ADDENDUM NO. 1
February 26, 2021
224126

RE: **CITY OF BARRE, VERMONT**
BIOSOLIDS IMPROVEMENTS PROJECT

FROM: DuBOIS & KING, INC.
P.O. Box 339
Randolph, Vermont 05060
(802) 728-3376

C9

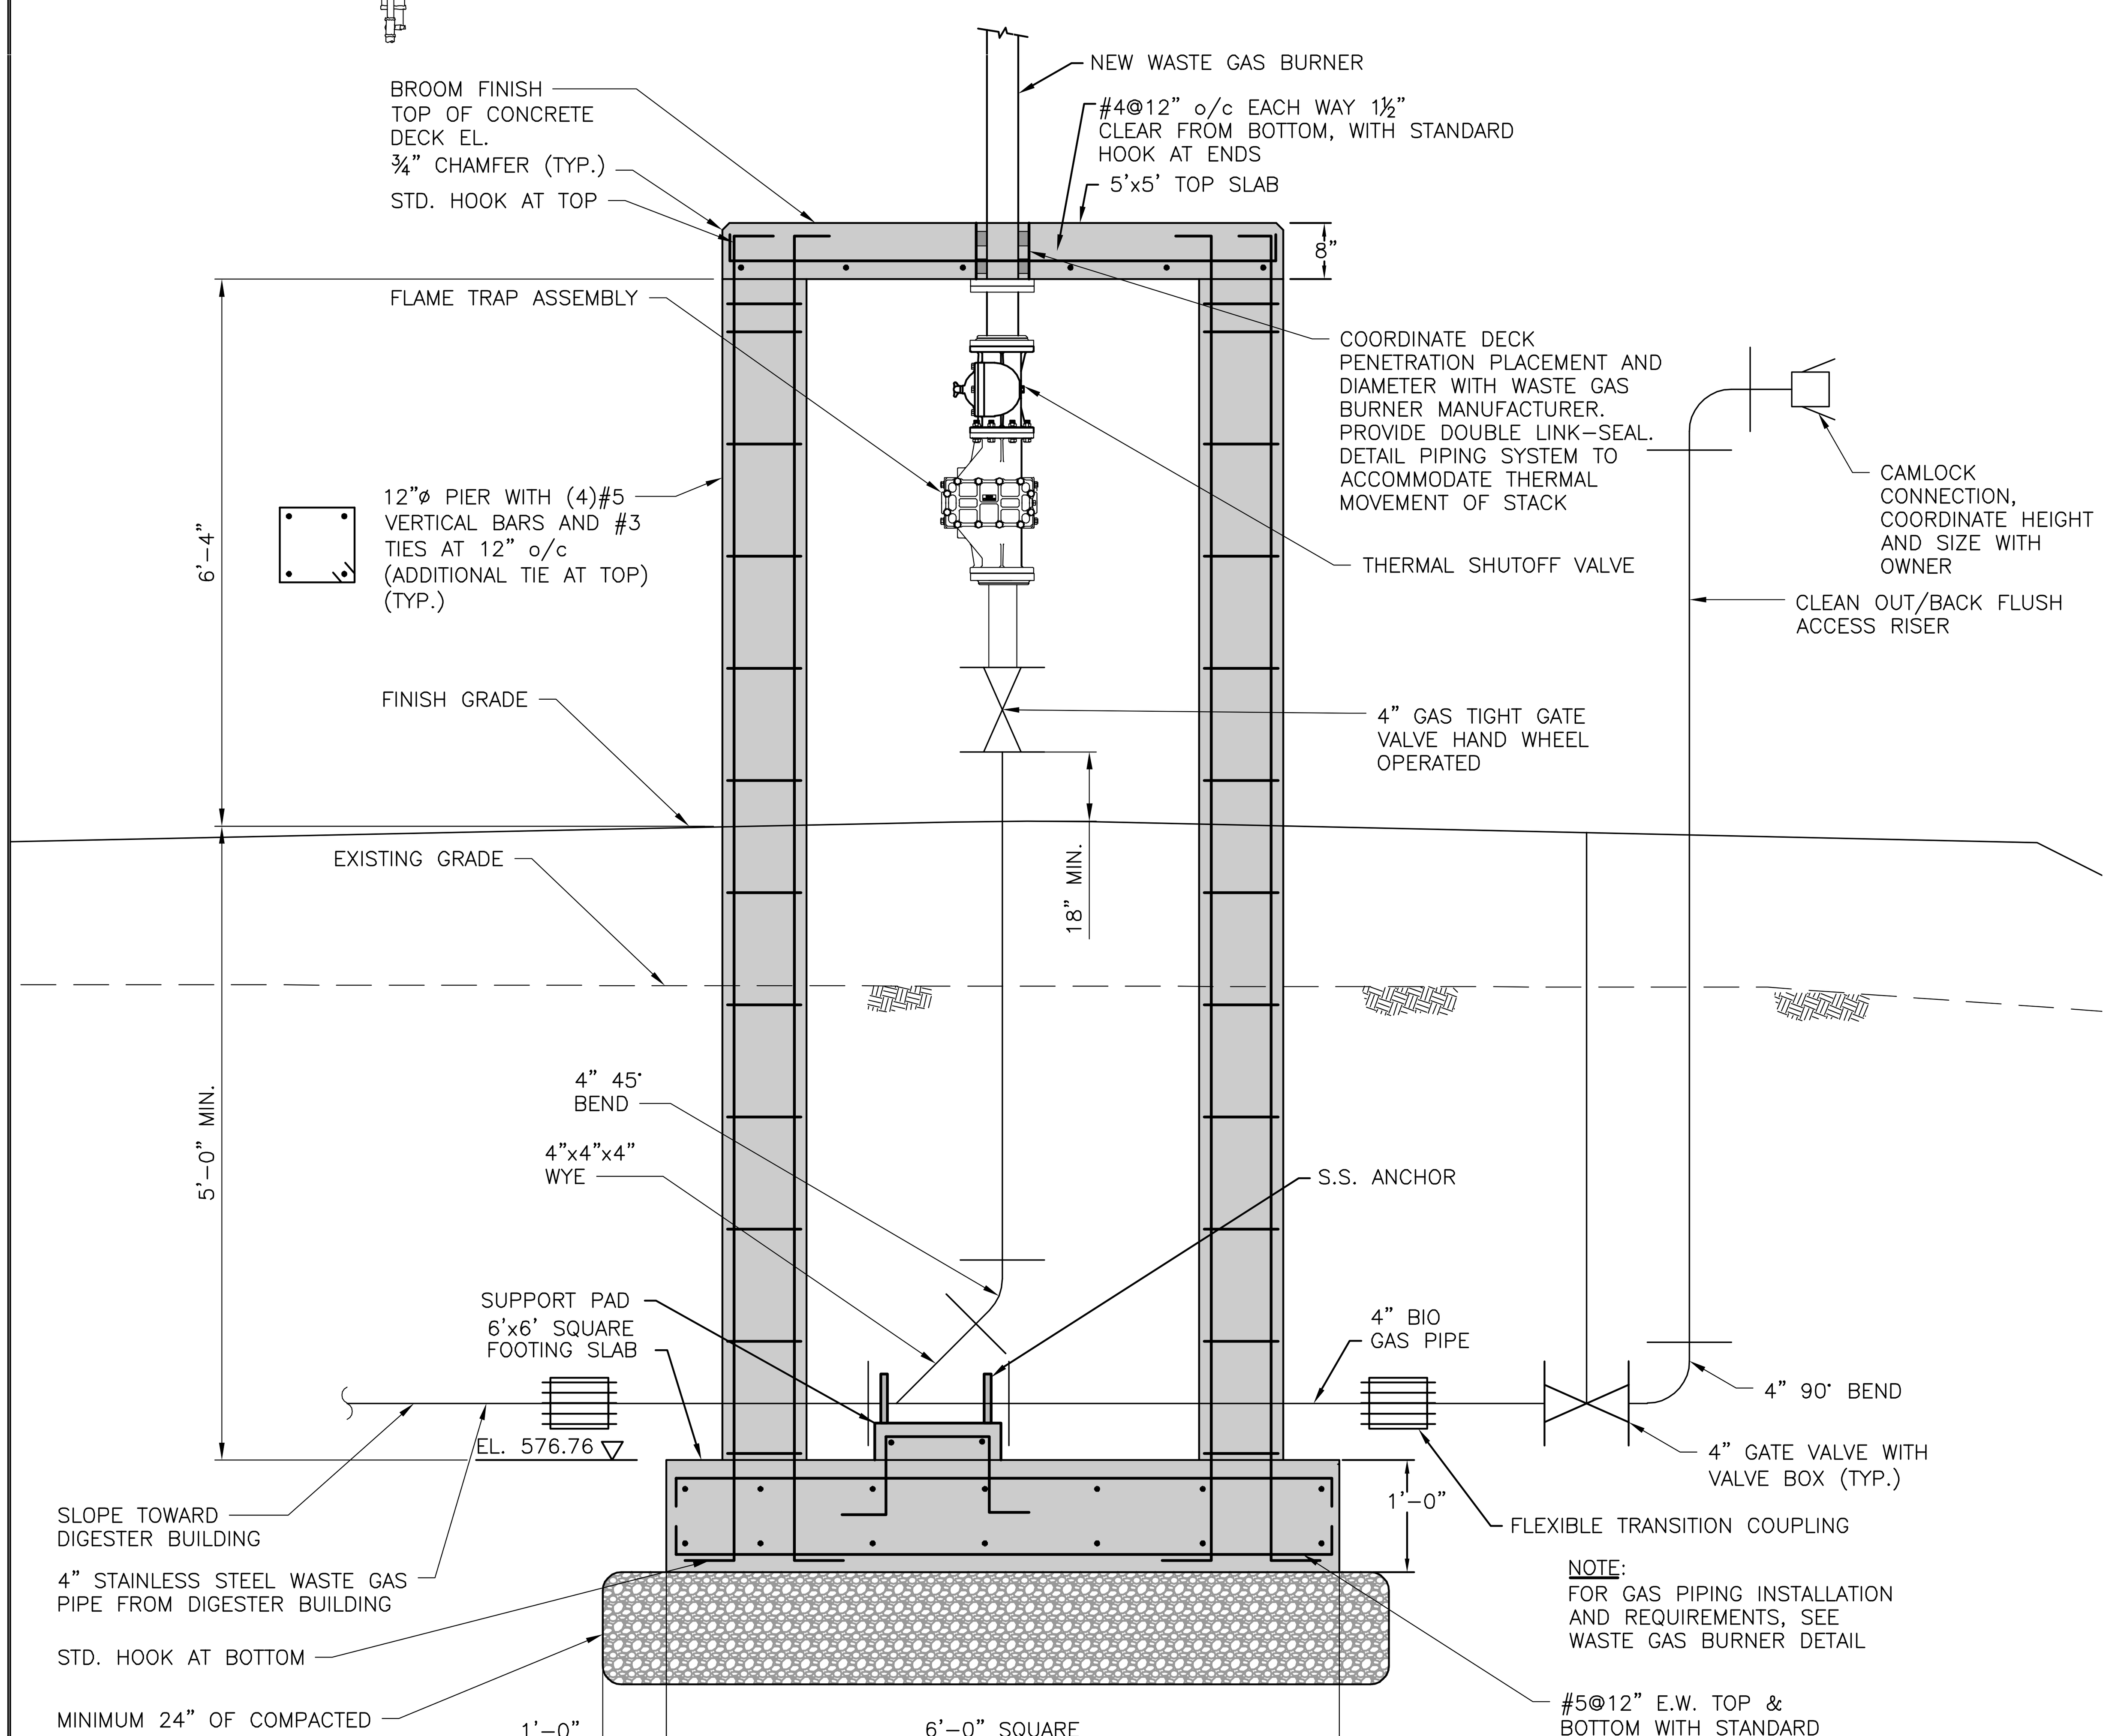
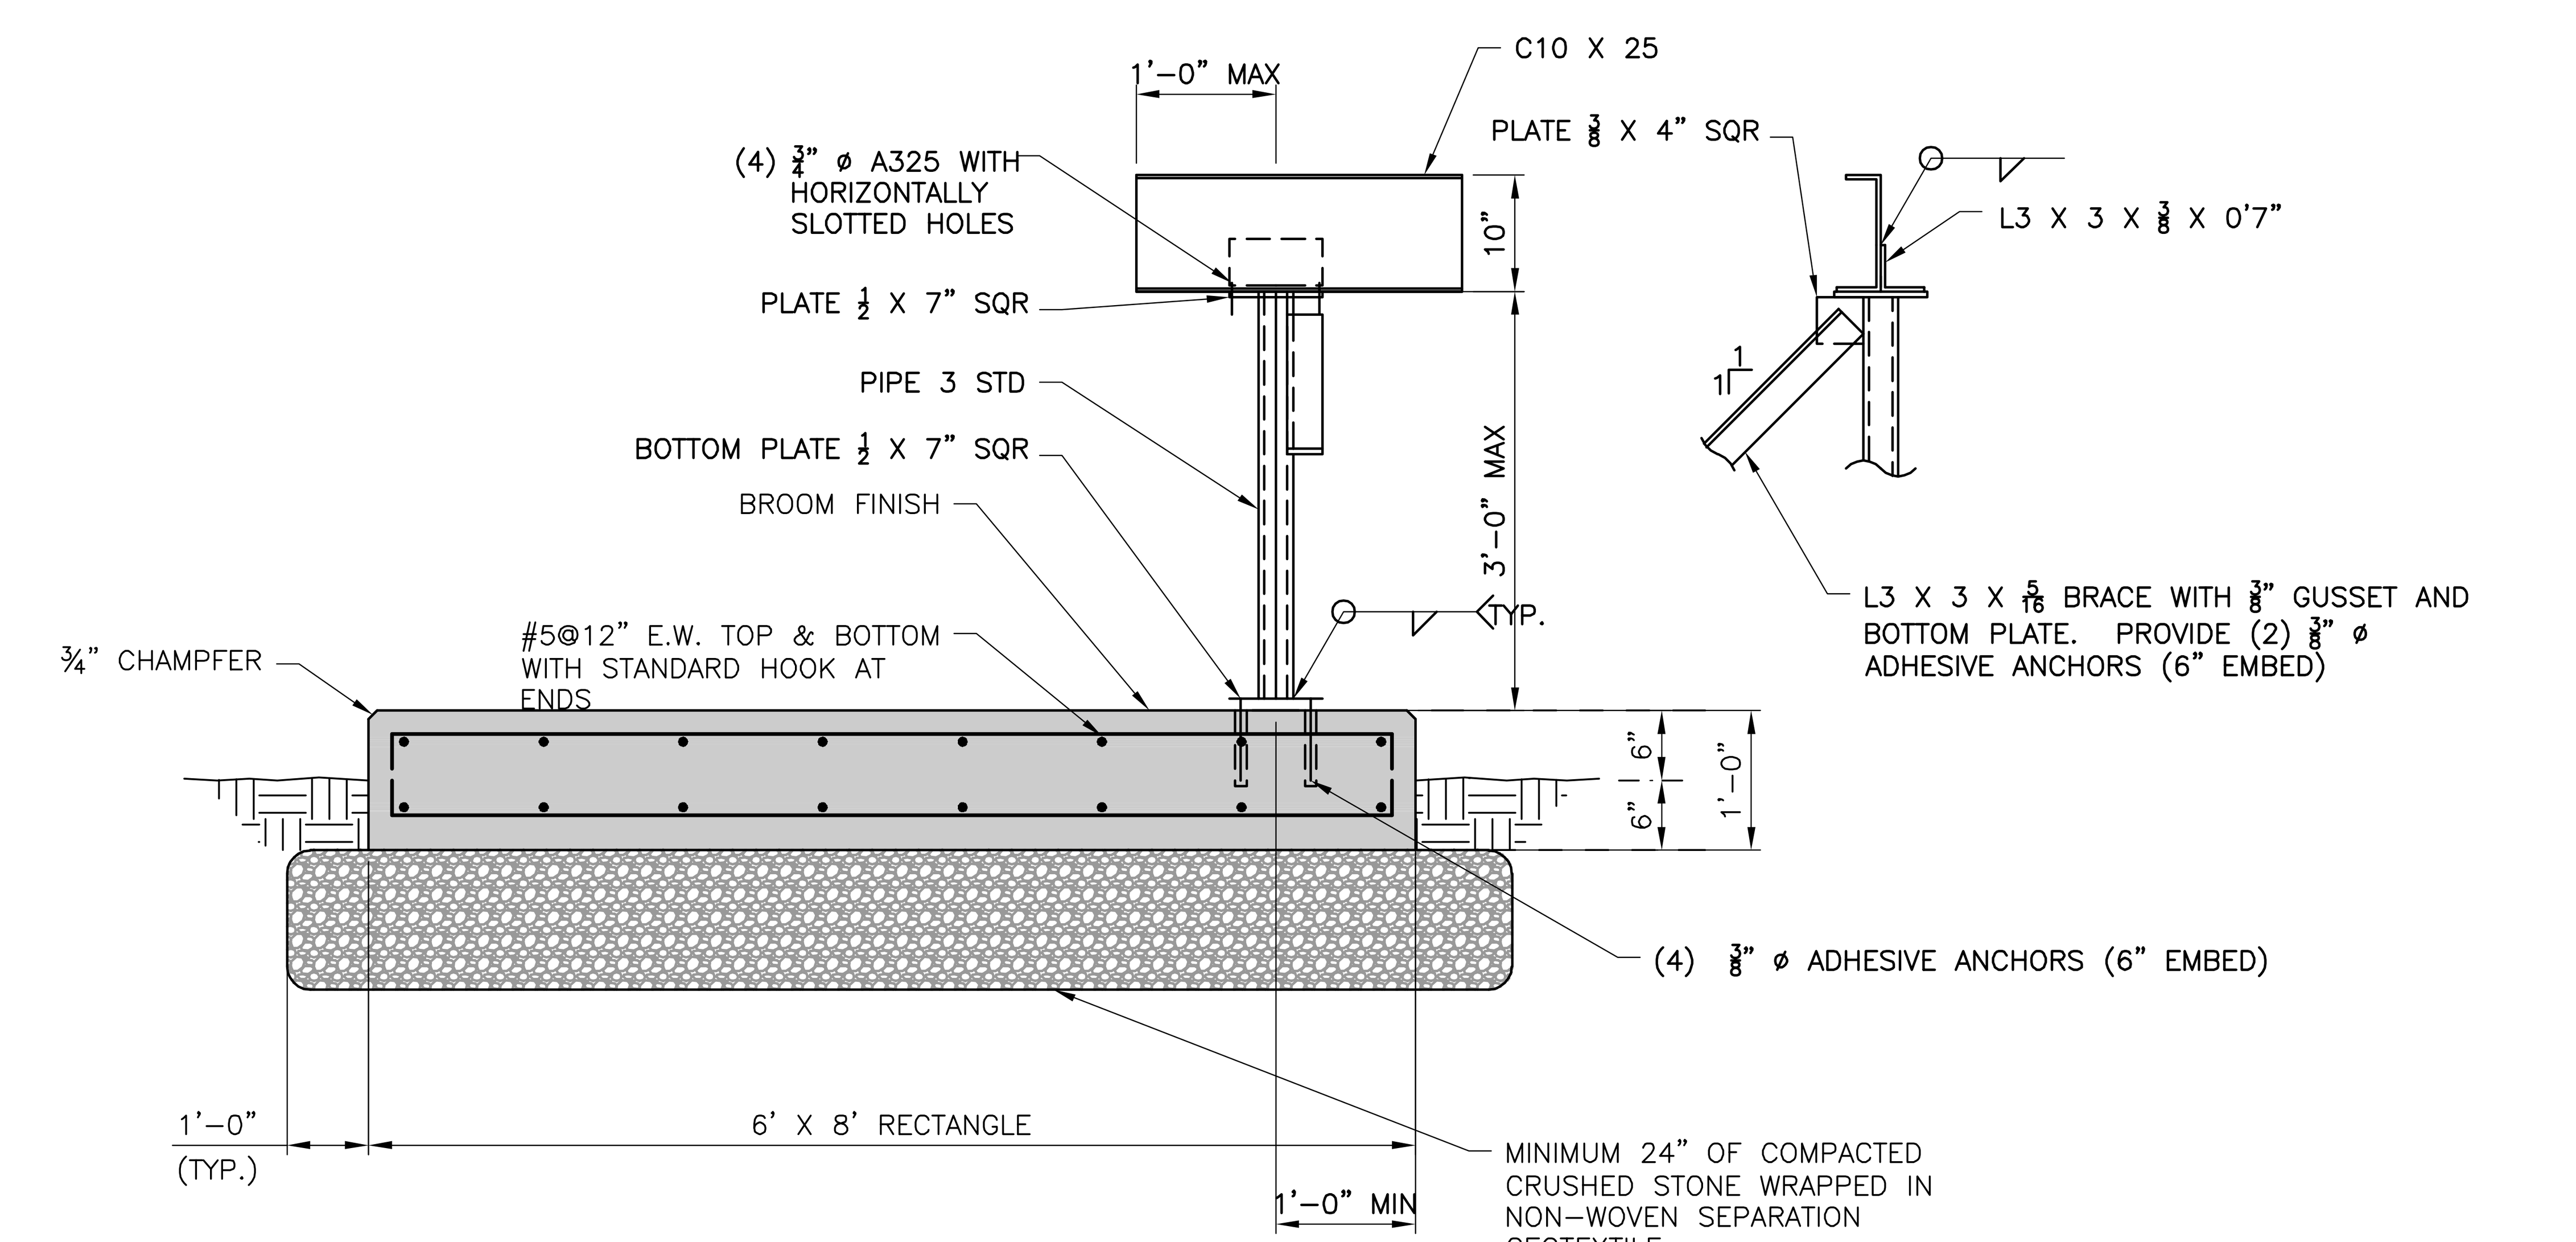
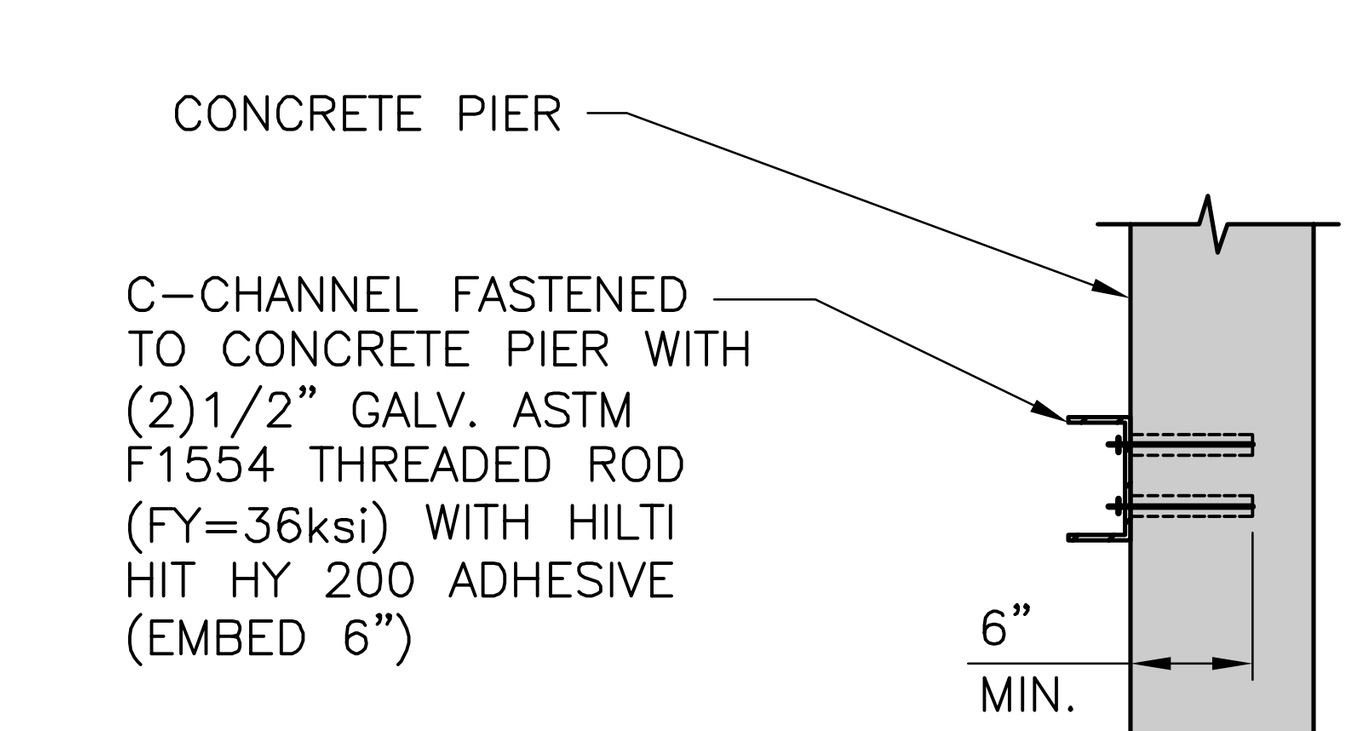
Question 12: In reference to **Sheet C8**, will support piers be required to support the 10" channel?

6. Reissue sheet C9. See **Attachment 3**.

Answer 12: The channel was sized/designed to span the identified length. The channel is attached to the concrete pier on one end. The reissued Sheets C8 and C9 identify a support on the concrete pad associated with the Gas Burner Control Panel.
